**RE: ADDENDUM TO HYDROQUEST REPORT OF SEPTEMBER 15, 2015:  
ADDITIONAL KARST AQUIFER DISCUSSION**

**RE: Hydrogeologic Considerations Relative to the Proposed Conditioned Negative Declaration for the 109-125 Marbledale Road Brownfield Development; Tuckahoe, New York**

**Figure 4**

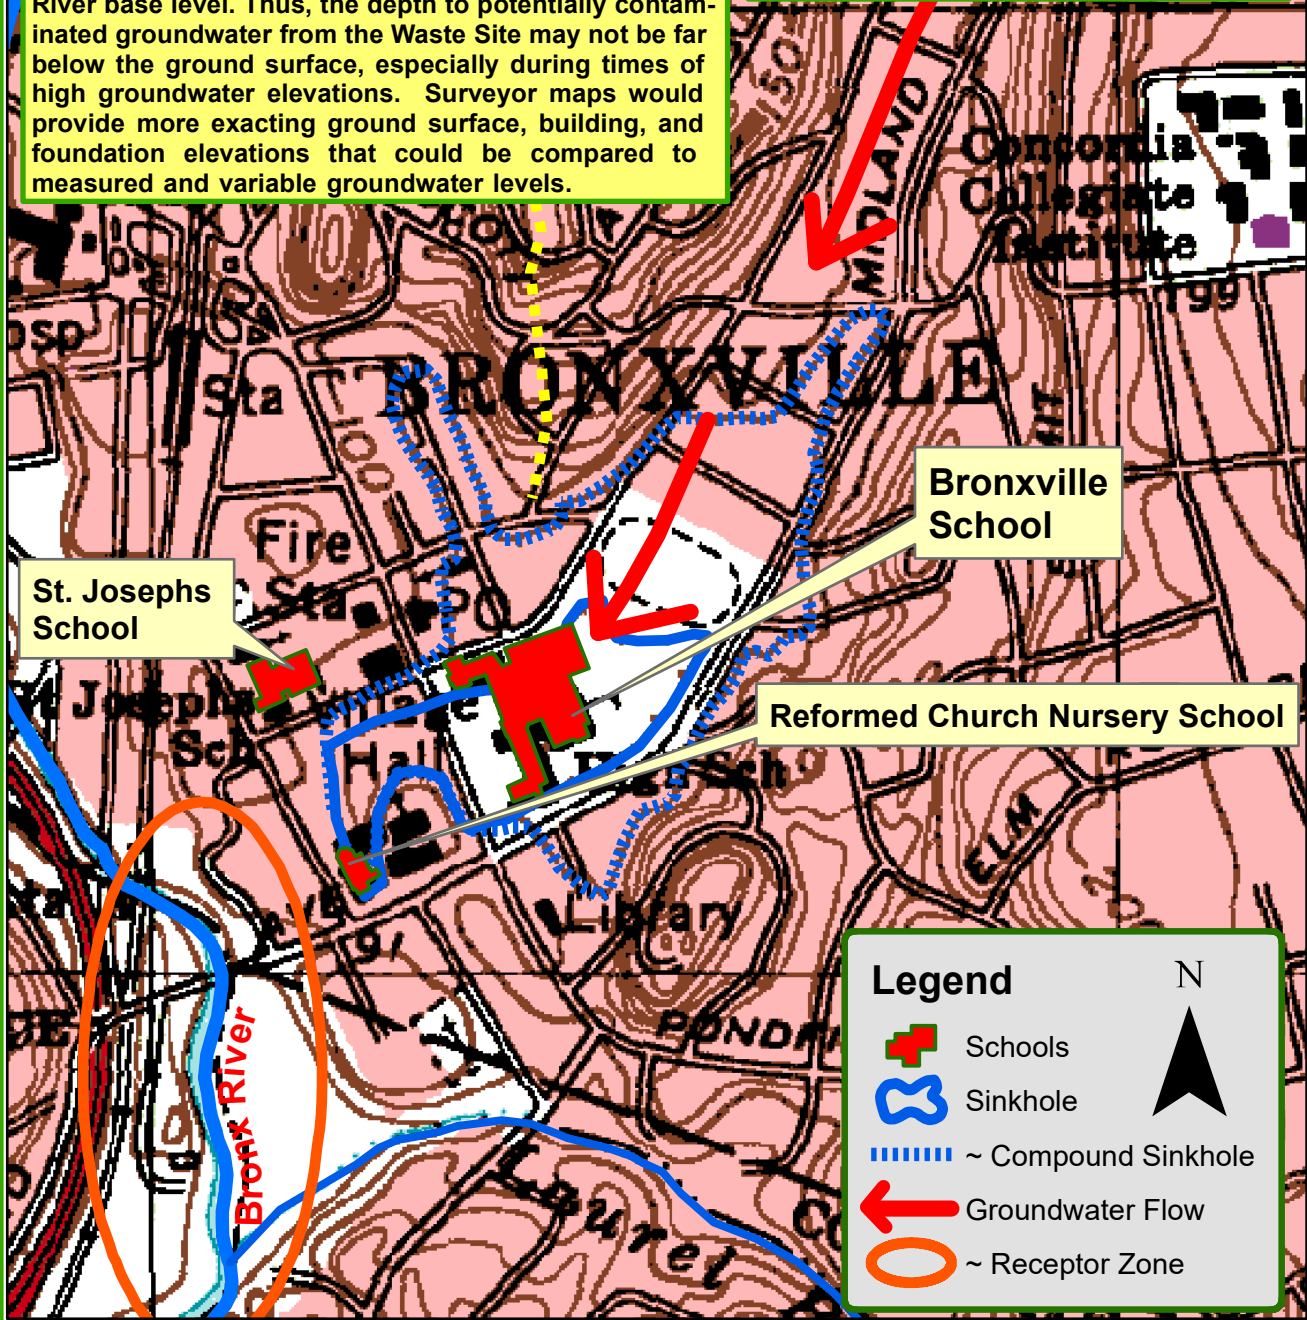
Figure 4 examines the potential depth to groundwater and a few of the many potential contaminant receptors located along the groundwater flow path between the Marbledale Road chemical waste site and the Bronx River (e.g., Bronx School, Reformed Church Nursery School). Any new or existing buildings situated along the alignment of the Inwood Marble that have deep foundations in bedrock that penetrate the groundwater table or have foundation inverts close to it have the potential of being contaminant receptors (e.g., for waterborne and airborne volatile organic chemicals). To date, the former marble quarry landfill site has been partially examined within the limited confines of the site area property itself, under the misguided concept that developing buildings and capping/covering much of the site area will in any significant or meaningful way stop the off-site migration of hazardous contaminants. Instead, premature site development will make it difficult or impossible to effect remedial actions or contaminant removal efforts should additional site testing and characterization support such actions.

The elevation of the groundwater table down gradient of the Waste Site grades downward to the Bronx River in the Receptor Zone, an elevation of approx. 70 ft msl. The elevation of the Bronxville High School as shown on this USGS map, and on modeled elevational data, is approx. 90-95 ft msl - roughly 20-25 ft above the Bronx River base level. Thus, the depth to potentially contaminated groundwater from the Waste Site may not be far below the ground surface, especially during times of high groundwater elevations. Surveyor maps would provide more exacting ground surface, building, and foundation elevations that could be compared to measured and variable groundwater levels.

Figure 6

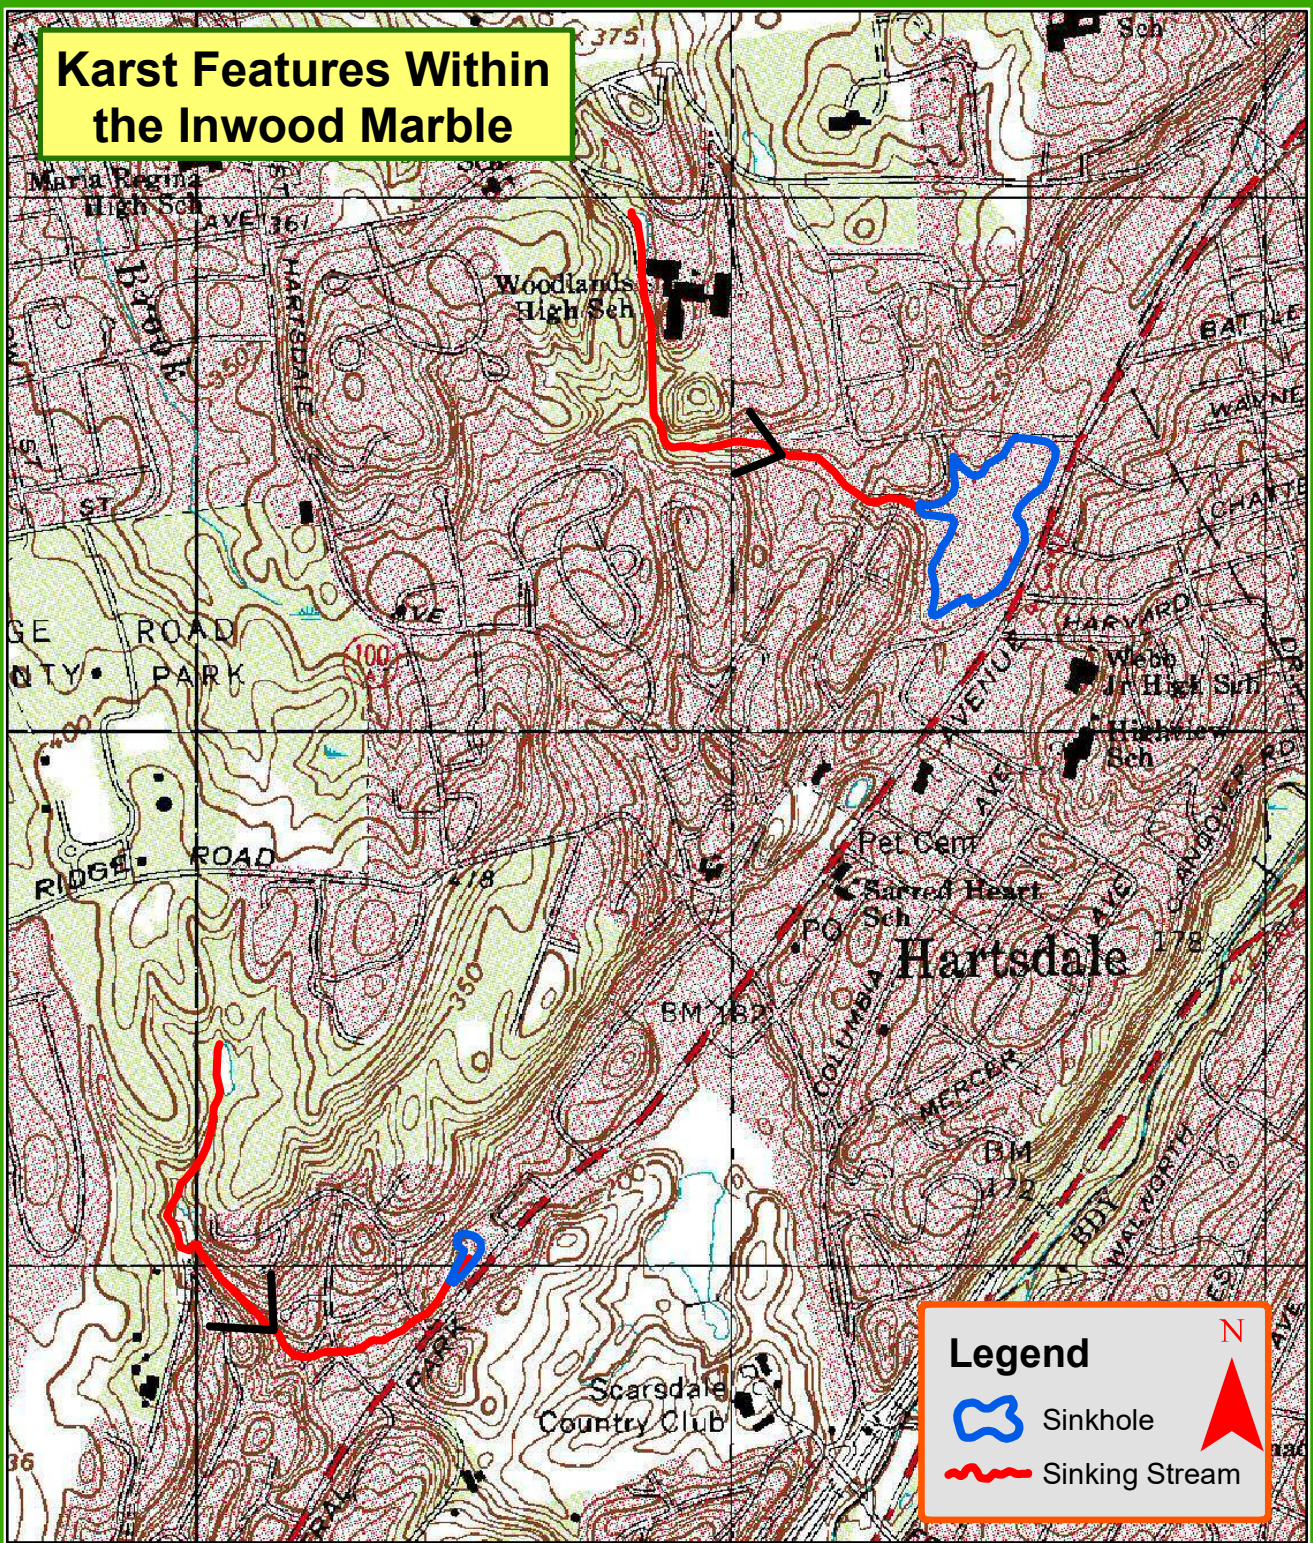
The HydroQuest September 2015 report details some of the important aspects of the karst aquifer that is present up-gradient, through, and down-gradient of the Marbledale Rd. chemical waste site. HydroQuest Figures 3 (Bedrock Geology), 4 and 5 depict sinkholes within the valley-axial trending karst aquifer over which the Marbledale Road chemical waste site was developed. Karst hydrogeologists of the world would quickly recognize the setting as karstic and would then proceed to further characterize it using methods developed specifically for delineating karst aquifers.

# Topography

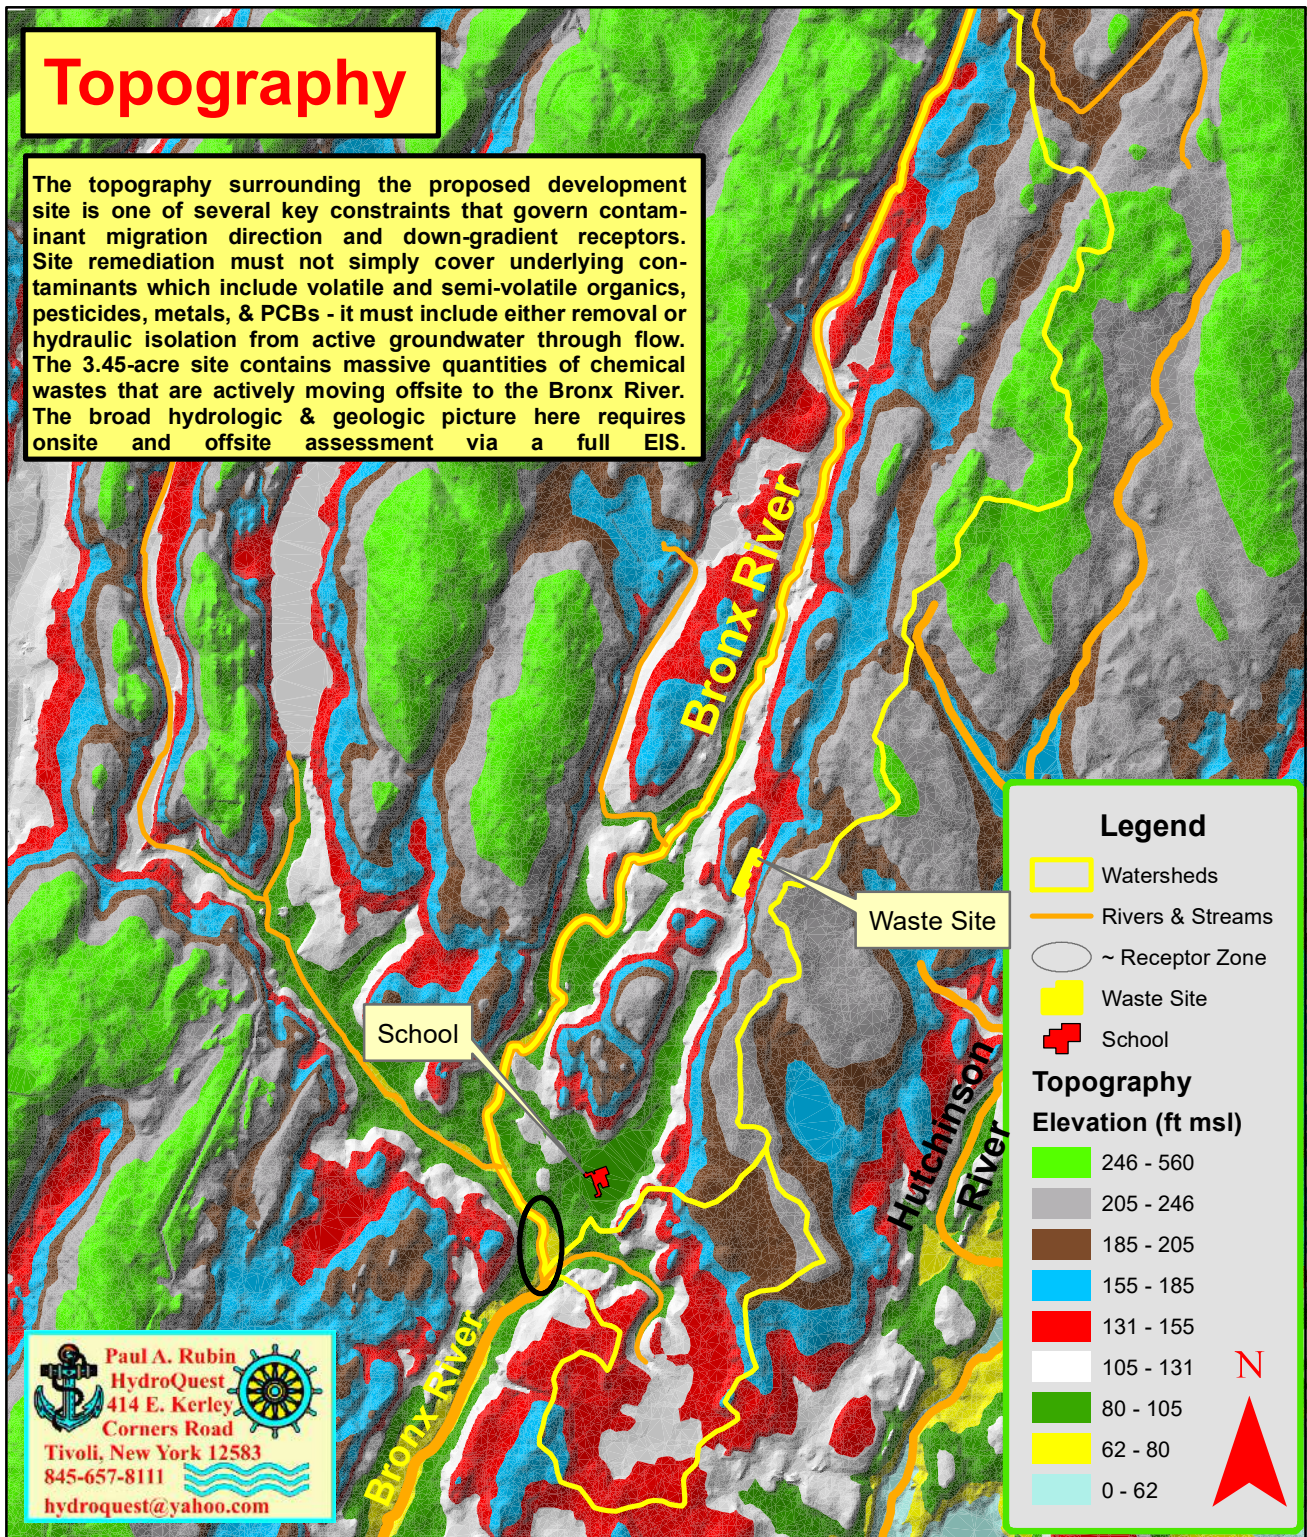
The topography surrounding the proposed development site is one of several key constraints that govern contaminant migration direction and down-gradient receptors. Site remediation must not simply cover underlying contaminants which include volatile and semi-volatile organics, pesticides, metals, & PCBs - it must include either removal or hydraulic isolation from active groundwater through flow. The 3.45-acre site contains massive quantities of chemical wastes that are actively moving offsite to the Bronx River. The broad hydrologic & geologic picture here requires onsite and offsite assessment via a full EIS.

# Surface Hydrology

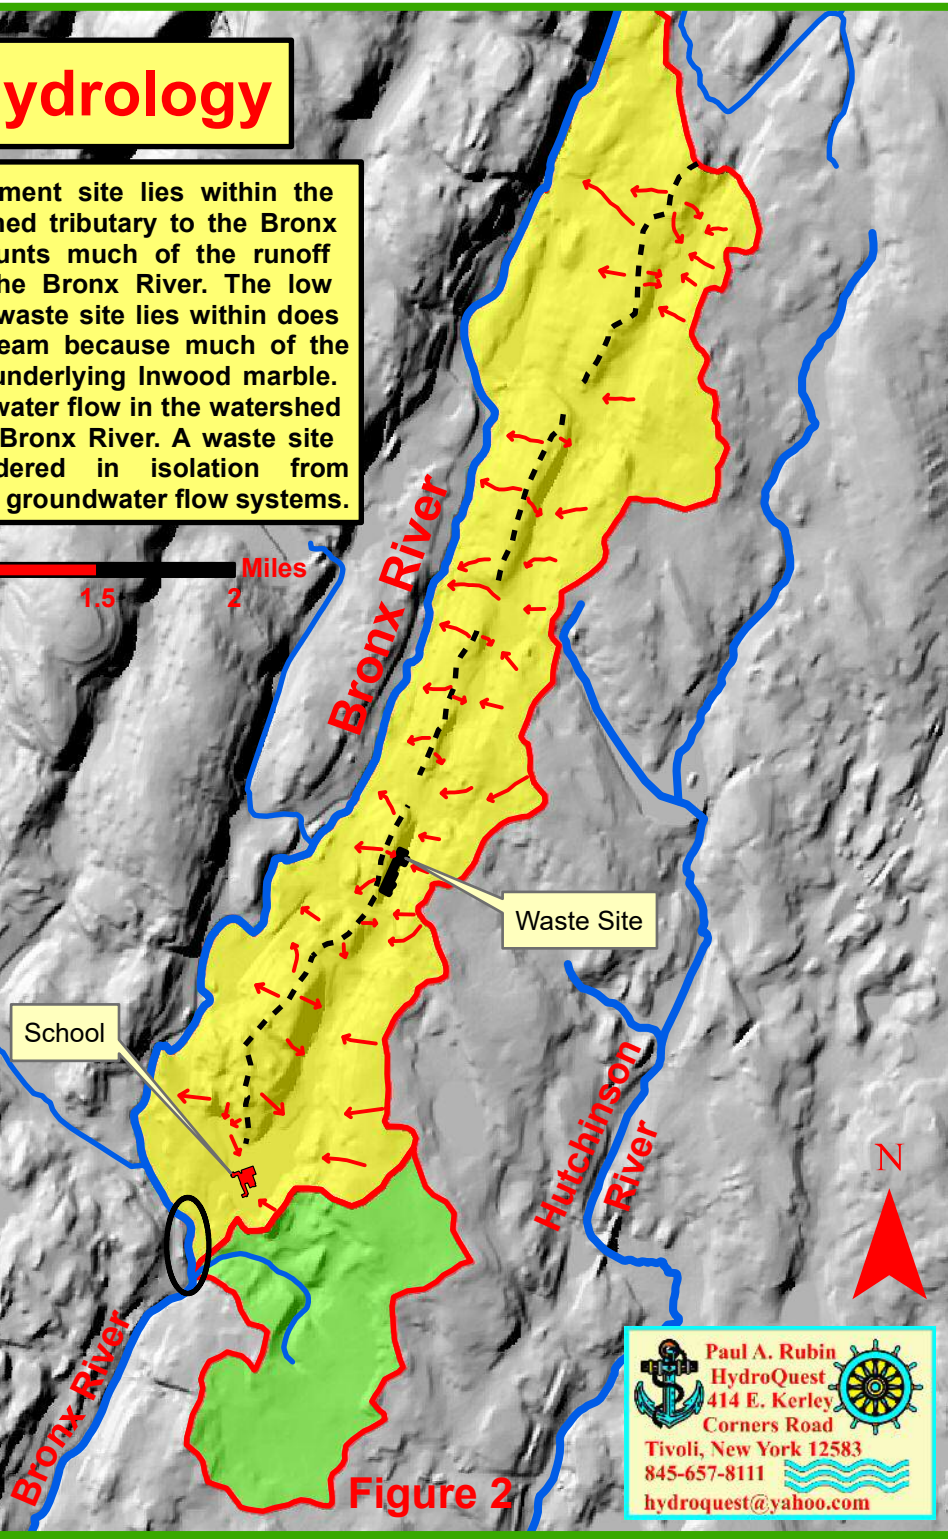
The proposed development site lies within the yellow surficial watershed tributary to the Bronx River. A ridgeline shunts much of the runoff westward directly to the Bronx River. The low topographic valley the waste site lies within does not have an active stream because much of the runoff is lost into the underlying Inwood marble. All surface and groundwater flow in the watershed must discharge to the Bronx River. A waste site must not be considered in isolation from functioning surface and groundwater flow systems.

Figure 3

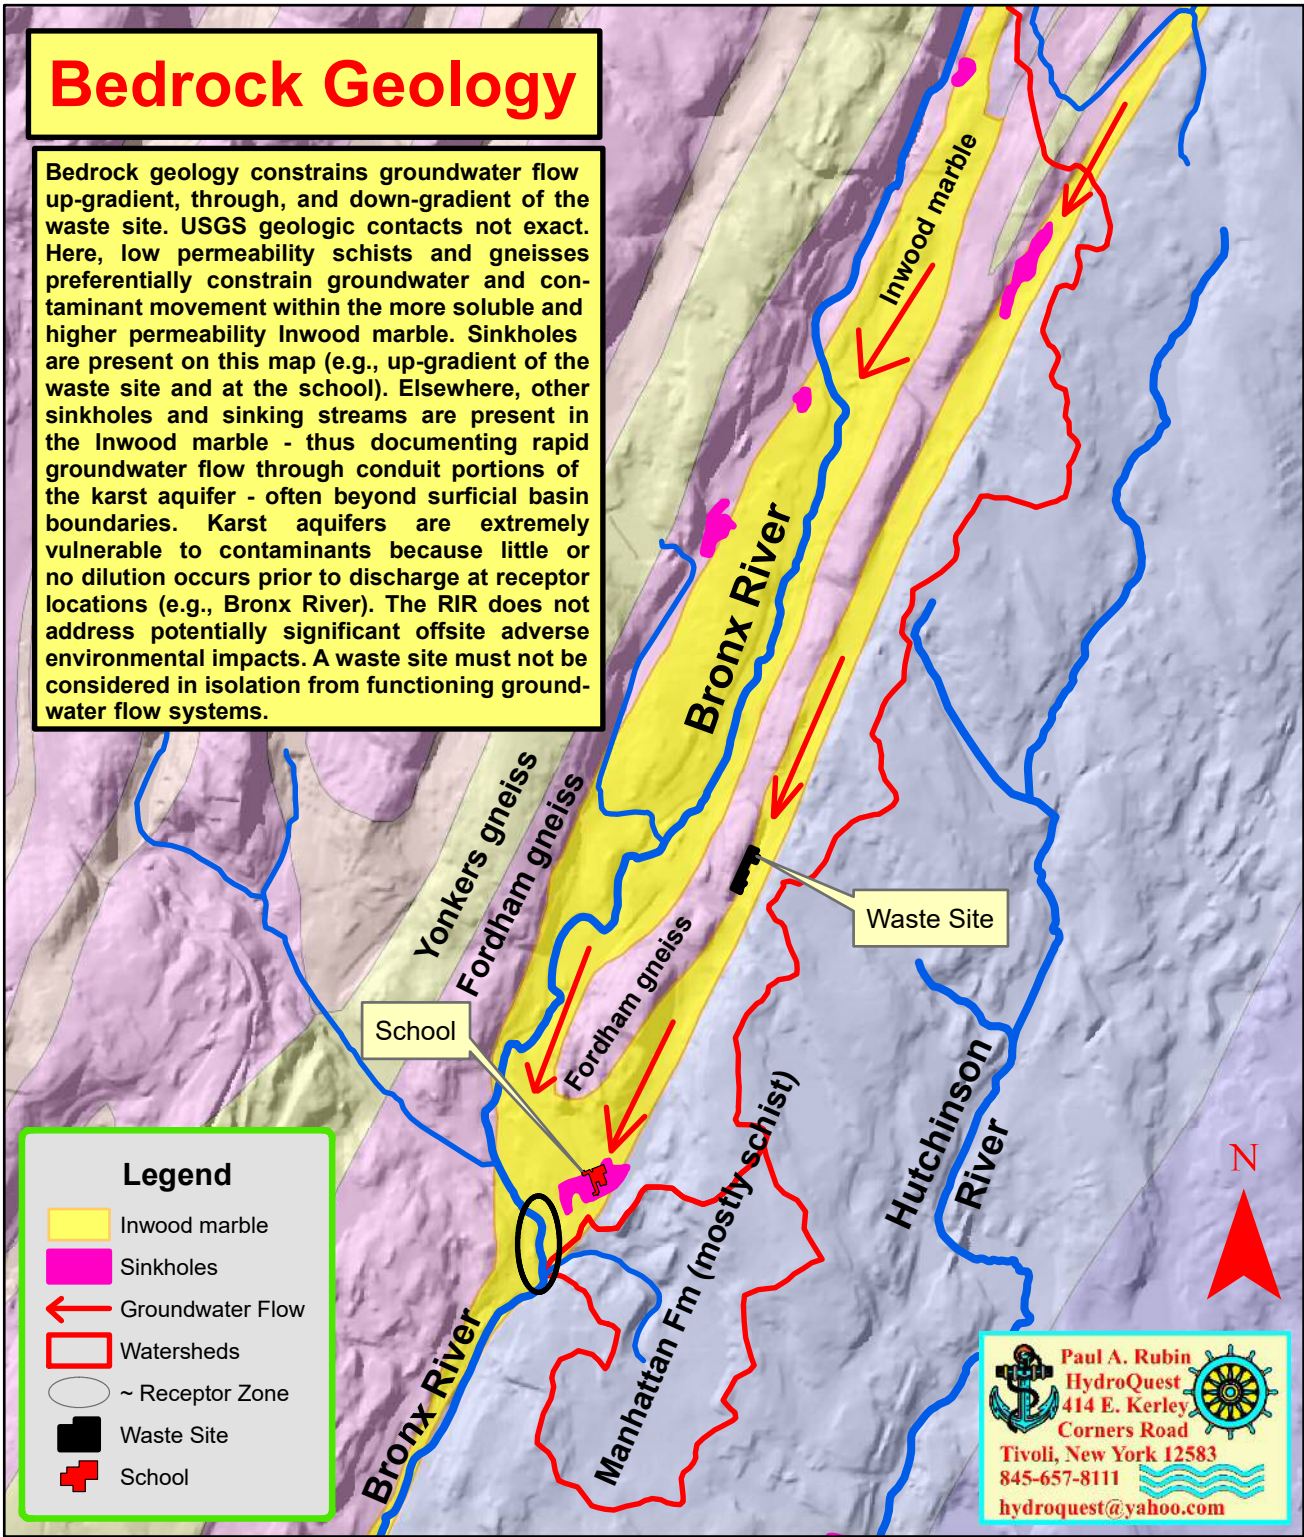
**Contaminants migrating down-gradient from the Marbledale Road waste site may adversely impact receptors along the subsurface flow path in addition to the water quality of the Bronx River. A large school is present within an expansive sinkhole situated above or within the karst aquifer (Figure 3). Depending on the physical setting of the school building, it is possible that volatile organic chemicals from the waste site may vaporize into the school building. Approving the proposed development in the absence of completion of an EIS may preclude viable remedial options. Considering the large scale of the waste site, it is critical to address the whole hydrologic picture, not just site-specific details.**

Depending on the material used to cap the waste site, different impacts are possible. However, even if an impermeable cover is used to reduce infiltration of rainfall and snowmelt, contaminants would still migrate off site. As depicted on HydroQuest Figure 3, groundwater flow within soils and the Inwood marble aquifer occurs from up-gradient of the site, through the site, and to receptors down-gradient of the site. The site area comprises only a small portion of the flow route, thus capping the site will have little impact towards reducing contaminant transport offsite.

Bedrock geology constrains groundwater flow up-gradient, through, and down-gradient of the waste site. USGS geologic contacts not exact. Here, low permeability schists and gneisses preferentially constrain groundwater and contaminant movement within the more soluble and higher permeability Inwood marble. Sinkholes are present on this map (e.g., up-gradient of the waste site and at the school). Elsewhere, other sinkholes and sinking streams are present in the Inwood marble - thus documenting rapid groundwater flow through conduit portions of the karst aquifer - often beyond surficial basin boundaries. Karst aquifers are extremely vulnerable to contaminants because little or no dilution occurs prior to discharge at receptor locations (e.g., Bronx River). The RIR does not address potentially significant offsite adverse environmental impacts. A waste site must not be considered in isolation from functioning groundwater flow systems.
